**CITY OF CODY**  
**SPECIAL MEETING OF THE PLANNING, ZONING AND ADJUSTMENT BOARD**  
**AGENDA**  
**TUESDAY, JULY 25, 2023 AT 6:00 P.M.**  
**CODY AUDITORIUM, 1240 BECK AVENUE, CODY, WY**

CITY OF CODY PLANNING, ZONING AND ADJUSTMENT BOARD STAFF REPORT			
<b>MEETING DATE:</b>	JULY 11, 2023	<b>TYPE OF ACTION NEEDED</b>	
<b>AGENDA ITEM:</b>		P&Z BOARD APPROVAL:	X
<b>SUBJECT:</b>	CODY WYOMING TEMPLE OF THE CHURCH OF JESUS CHRIST OF LATTER-DAY SAINTS. SITE PLAN REVIEW. FILE NOS: SPR 2023-13	RECOMMENDATION TO COUNCIL:	
<b>PREPARED BY:</b>	TODD STOWELL, CITY PLANNER	DISCUSSION ONLY:

<b>MEETING DATE:</b>	JUNE 15, 2023	<b>TYPE OF ACTION NEEDED</b>	
<b>AGENDA ITEM:</b>		P&Z BOARD APPROVAL:	X
<b>SUBJECT:</b>	CODY WYOMING TEMPLE OF THE CHURCH OF JESUS CHRIST OF LATTER-DAY SAINTS. FILE NOS: SPR 2023-13, SUP 2023-08 (BOTH CUP AND SE), AND FNC 2023-01	RECOMMENDATION TO COUNCIL:	
<b>PREPARED BY:</b>	TODD STOWELL, CITY PLANNER	DISCUSSION ONLY:

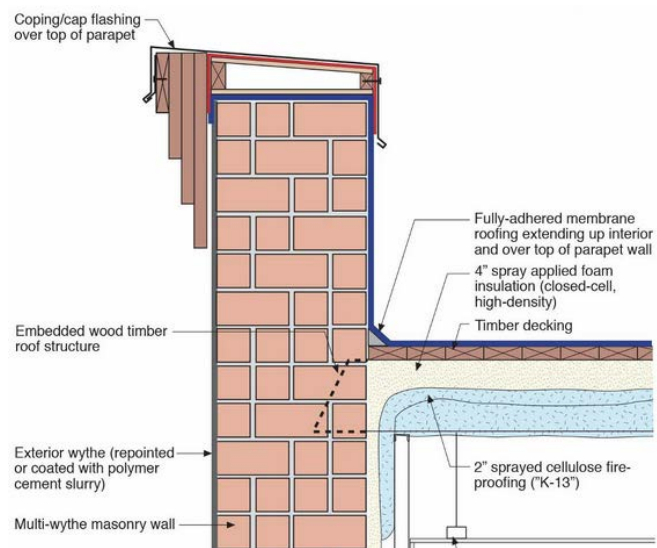
While I have not seen the building permit set of plans for the Cody temple, the architect has recently stated that the roof and steeple concept used for the Cody temple is almost exactly the same as the Helena temple, differing only in the shape of the steeple. What I discovered while viewing a time-lapse video of the Helena temple construction is that there is no roof or skylight (for those familiar with the Billings

temple skylight) above the flat membrane roof that covers the main level of the building. The panels that visually form the base of the temple steeple are actually suspended by a steel framework above the roof of the temple and are entirely open vertically—rain and snow would fall all the way to the roof of the main level, which is below the 24-foot-tall parapet wall. The steeple base has no roof. The flat roof on the temple is immediately above the ceiling of the occupied space of the main level. No portion of the steeple contains space that is considered habitable or that would be occupied.

Now that we know the location of the flat roof, the next question for determining “building height” of the temple is “What is the highest point of the coping” associated with that flat roof? Coping is the weatherproof flashing that protects the top of a parapet wall—see insert (*Building Science.com*, accessed 6.2.2023). A parapet is “a low wall along the edge of a bridge, a roof, etc. to stop people from falling.” (*oxfordlearnersdictionaries.com*, accessed 6.1.1023)

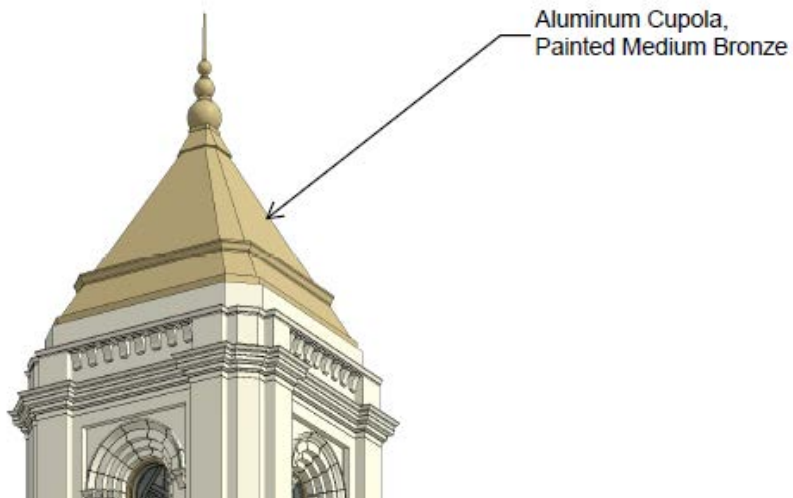
In the case of both the Helena and Cody temples, the only parapet walls are found around the perimeters of the buildings—the panels that form the visual base of the steeple are not parapets, as they are suspended above the roof. Therefore, the coping on the 24-foot-tall parapet walls of the proposed temple constitutes “the highest point of the coping” to which building height is measured.

The cupola is technically a component of the steeple, but in the shape of a hip style roof, which may at first suggest that building height should consider the cupola. However, the cupola does not form the “main roof” of the building. Its size is only a small fraction of the flat roof below. As such, part “c” of the building height

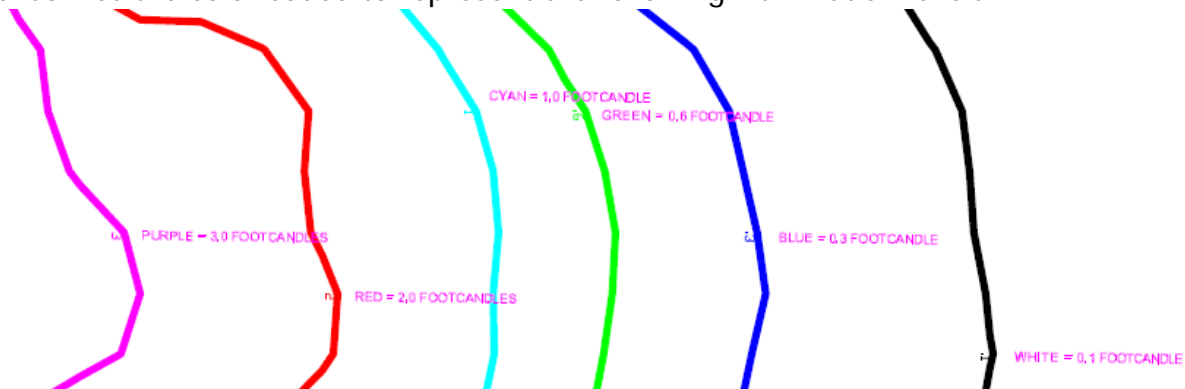
As requested by the City, the applicant has voluntarily provided photometric maps of the proposed temple site to demonstrate whether light would be largely contained within the property or not. The maps have been available on the City website with the public hearing notice. You need to download the file in order to be able to zoom in to clearly read it. Photometric maps show how much illumination is calculated to occur at specific locations on the property, based on the specific light fixtures proposed and a horizontal surface. The numbers represent how many footcandles are at each point.

The illumination levels at the east property line are below 0.1 footcandles (almost nothing), except for the lighting of the entry road, and that light is reduced to 0.1 levels by the time it reaches the neighbor's lot.

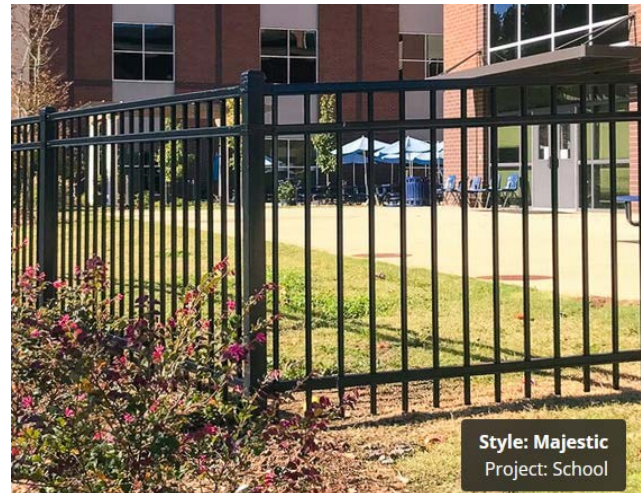
No trees are authorized in the City right-of-way along the east side of the temple site. Any shrubs, bushes and other woody vegetation placed in the City right-of-way will need to meet the standards of City code [7-4](#) (relates to spacing from utility lines). The landscaping plan will need to be revised accordingly. Grass or other groundcover in that area remains an option. Any disturbed areas beyond the landscaped areas that lack vegetation are to be planted with dryland grass seed, or any better alternative method authorized by Public Works, to help prevent weeds and control erosion.

Landscaping in the immediate area around the electrical switch gear cabinet must consider the minimum clearances required. Depending on the size of the cabinet, some of those shrubs shown nearest the cabinet may need to be removed from the plan.

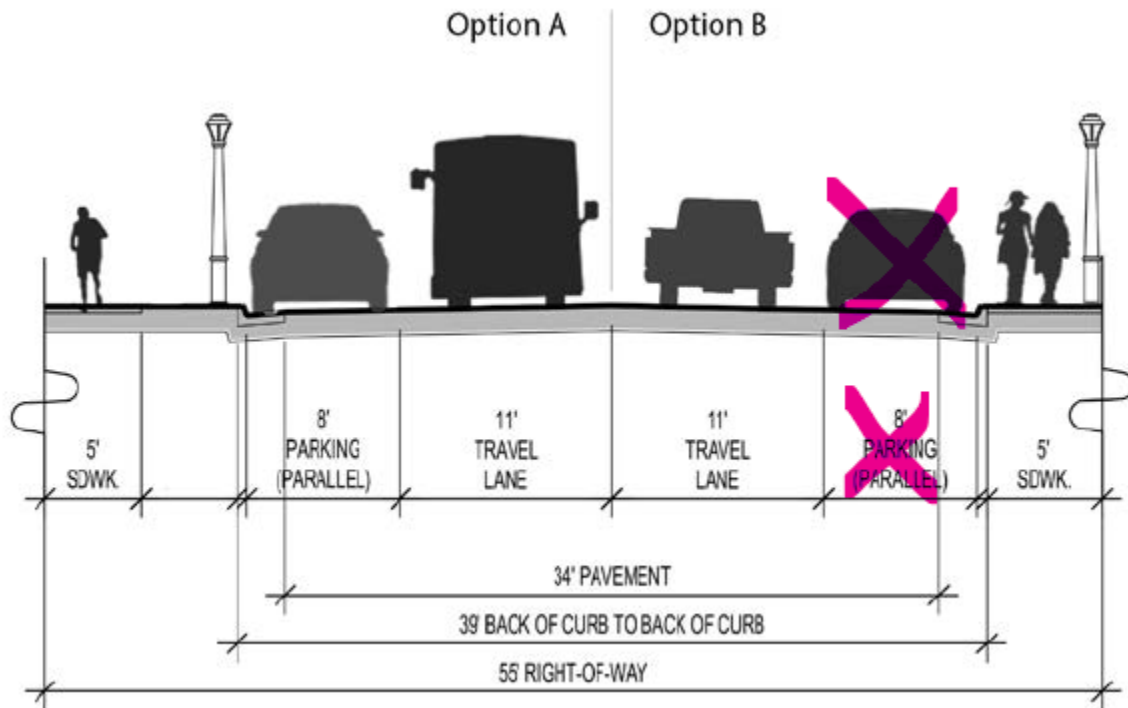
The proposed access situation is shown on the site plan. A new street, to be known as "Temple View Lane" will be constructed from Skyline Drive, along the south boundary of the temple site, ending in a cul-de-sac bulb. Two accesses to the temple site will be from that new street, as shown. Although the eastern temple access is on City right-of-way, City staff have indicated their preference that that section be privately maintained, to which the applicant has verbally agreed. With the designation of private instead of public, staff recommends a memorandum of understanding, simply outlining that it is a private improvement, with no maintenance responsibility for the City, and that if the right-of-way is ever developed with a public street, the party constructing that street would have the right to remove and/or reconfigure that access as needed, working in good faith with the property owner. Current City staff put the probability of that right-of-way being improved with a public street as extremely close to zero—way too costly

and way too constrained by existing utilities and topography to justify such minimal traffic circulation benefit.

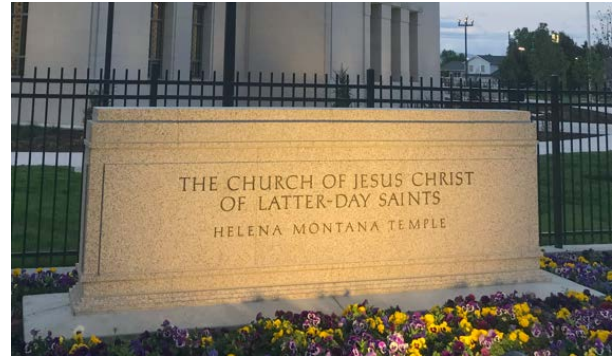
- a) The fire marshal states that one additional fire hydrant should be added to the temple site and one at the end of the cul-de sac. The additional hydrant for the temple site is recommended to be in the island near the fire line valving directly east of the temple building.
- b) If desired, the stormwater piping may be able to be reduced by relying more on gutter flow in the street entrance areas. In addition, the pipe to the ravine seems larger than needed.
- c) Black Hills Energy requests additional separation between the proposed natural gas line and the perimeter fence and electrical line. That could involve adjusting things a few feet, or just moving the gas line to the south side of Temple View Lane.

The electrical plan generally appears fine, but is missing the line from the existing fuse cabinet to the proposed transformer next to Skyline Drive. Also, shift the proposed transformer slightly to allow room for a future sidewalk along Skyline Drive (min. 5 feet behind back of curb.)
